INDEX TECHNICAL SERVICE BULLETIN

PRODUCT:	DATE:
COMMANDER® PPC(TM) (50)	17-FEB-98

COMMANDER® PPC(TM) Optics Filter Wheel Modification

TSB#: 50-038

Figure 2. Optics Filter Wheel with Heat Sink Installed

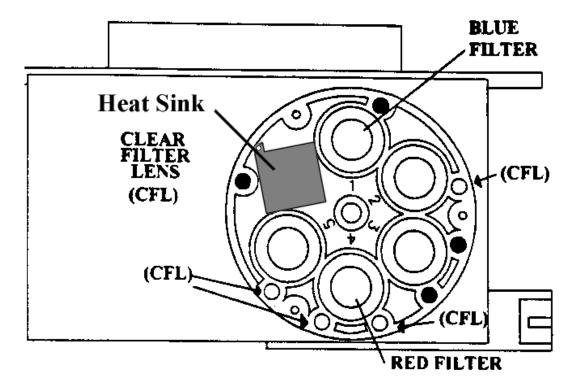
- a) Refer to Figure 2 below. The Heat sink should be installed at the "No Filter" position of the Filter Wheel.
 - b) Remove the heat sink from the plastic envelope.
 - c) Install the heat sink in the "No Filter" area with the tab on the heat sink extending over the rim of the filterwheel.
 - d) Maintain the position of the heat sink while pressing the ball end of an allen wrench against the corner with the tab. A typical wrench size is: 1/8 1/4. The heat sink corner is pressed in until the tab is totally obscured from view by the rim of the filterwheel. This requires that the tab bends at the angle to the heat sink surface and lodges on the inside wall of the rim.
 - e) Ensure that the heat sink is well secured in place. It should not move when trying to rotate or move it around with your finger.

Figure 1

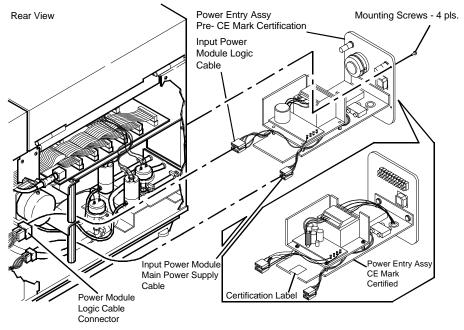
- 1. Removal of the Non-CE Mark Valve Mount, and Non-CE Mark Power Entry Assemblies.
 - a) Power down the PPC instrument, then pull up on the pressure relief ring on top of the water canister, to bleed off all system pressure.
 - b) Disconnect the air, water, waste tubing assemblies, and compressor AC power cord from the left side panel of the PPC instrument.
 - c) Remove the right rear cover on the PPC instrument. Disconnect, then remove and discard the Non CE Mark Valve mount assembly.
 - d) Disconnect, then remove the Non-CE Mark Power Entry from the PPC instrument. (Figure 1 shows both the CE and Non-CE Mark Power Entry configurations for further clarification)

Referencing Figure 1, locate the Input Power Module Logic Cable (8-pin, female connector) assembly connected to the Non-CE Power Entry assembly removed in step 1D.

Figure 3: Valve Mount Assembly, Rear View

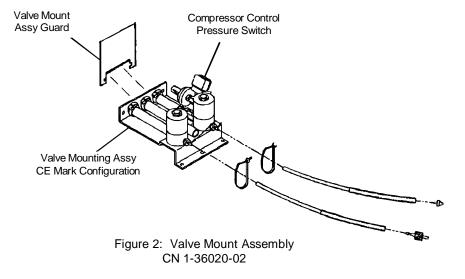
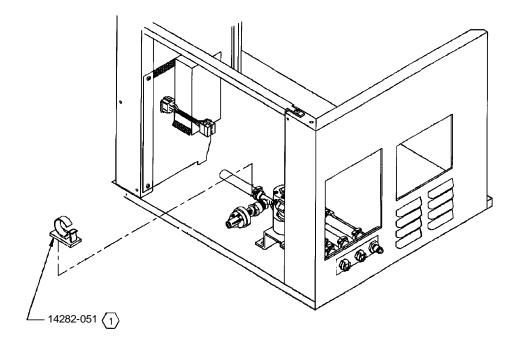
The -02 CE Mark Valve Mount assembly mounts identical to the -01 (non-CE Mark Version), with the exception of an added plastic shield to prevent any water from reaching the power entry area (see Figure 2). The Valve Mount assembly was also modified with a new pressure switch set at 24.75 +/-.25 P.S.I., that will control when AC power is switched on to the compressor cart. The pressure setting on the compressor regulator was also changed to 26 +/- .5 P.S.I. These changes will reduce overall compressor noise levels.

- a) Remove and discard the -01 (Non-CE Mark) valve mount assembly.
- b) Install the -02 (CE-Mark) valve mount assembly. Place the new valve mount shield between the valve mount and the PPC™ instrument side panel. Add the new locking clamp (14182-051) to better secure the waste pressure switch as shown in Figure 3.

Figure 5: Power Entry Front View

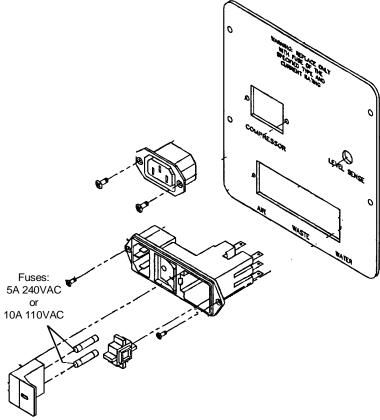
The CE Mark Power Entry Assembly mounts identical to the -01 (non-CE Mark Version). The Power Entry assembly was modified to include a new +12VDC CE approved Lamp Supply and a new fuse holder module as pictured (Figure 5).

- a) Remove the -01 (non-CE) Power Entry Assembly from the PPC™ instrument and replace it with the -02 version listed for this TSB upgrade.
- b) Checkout/Alignment of the Lamp Power Supply voltage will be performed in the final Validation step of this TSB. Proceed to step 4 of the upgrade procedures.
- 4. Printer Interface Cable, w/ferrite attached (CE-Mark Version 1-36294-02) Reference Figures 6/6A/6B.
 - a) Power down the PPC instrument. Remove the printer bracket in front of the printer assembly. (*Reference Figure 6*) Remove the Printer assembly from the instrument.
 - b) Remove the printer interface board cover, just behind the printer location.
